PZ&B Staff Combination Memorandum: Architectural Commission (ARCOM) and Town Council

SUBJECT: ARC-24-0022 (ZON-22-0014) 1246 N LAKE WAY

MEETING: AUGUST 28, 2024 ARCOM  
SEPTEMBER 11, 2024 TC

**ARC-24-0022 (ZON-24-0014) 1246 N LAKE WAY (COMBO)- VARIANCES.** The applicant, Myron and Michelle Miller, has filed an application requesting Architectural Commission review and approval to enclose an existing covered patio with a variance to exceed allowable Cubic Content Ratio. Town Council shall review the application as it pertains to zoning relief/approval.

***CURRENTLY PROPOSED SOUTH ELEVATION***

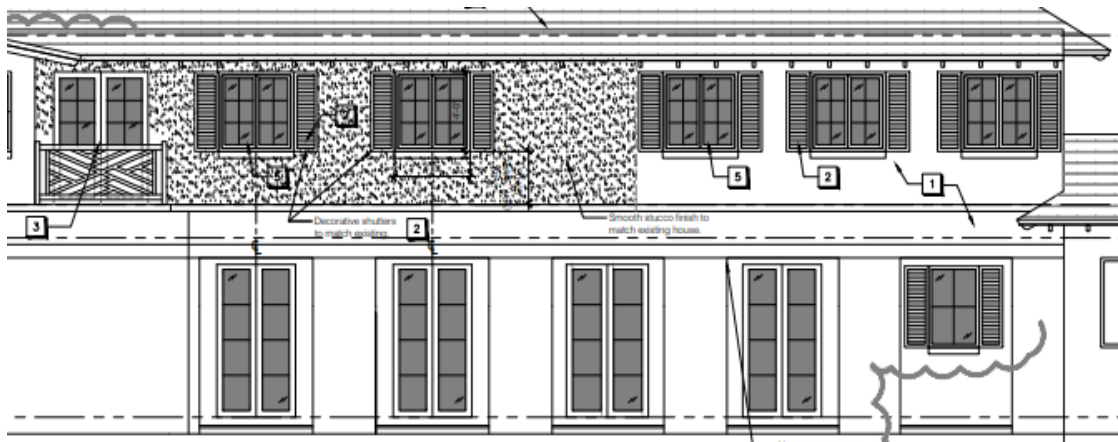
Following the deferral at the July hearing, the applicant has refined the proposed palette and material selections, aligning with the feedback provided. The previously approved shutter color, "Raccoon Fur" by Benjamin Moore, has been substituted with a more historically aligned tone, "Colonial Blue," also by Benjamin Moore. Additionally, the treatment of the window and door frames has shifted from the initial proposal of paint to white oak stain, harmonizing with the garage and front doors.

CURRENTLY PROPOSED EAST ELEVATION

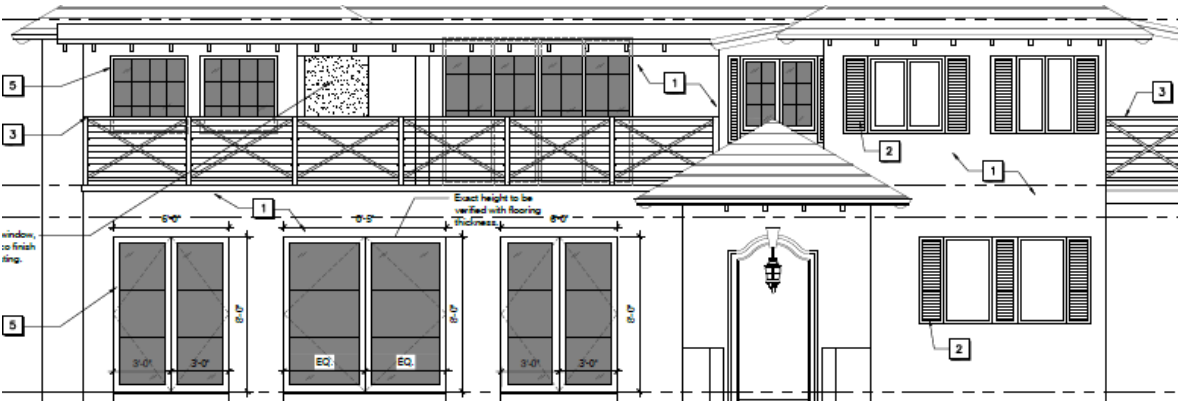
The east elevation now features the introduction of horizontal muntins on the nano door, contributing to a visually integrated design language. The balcony railings have been modified, moving away from the prior 42-inch white cross design to a more elegant and proportionally balanced 36-inch white Chippendale motif, providing a subtle yet distinguished architectural enhancement.
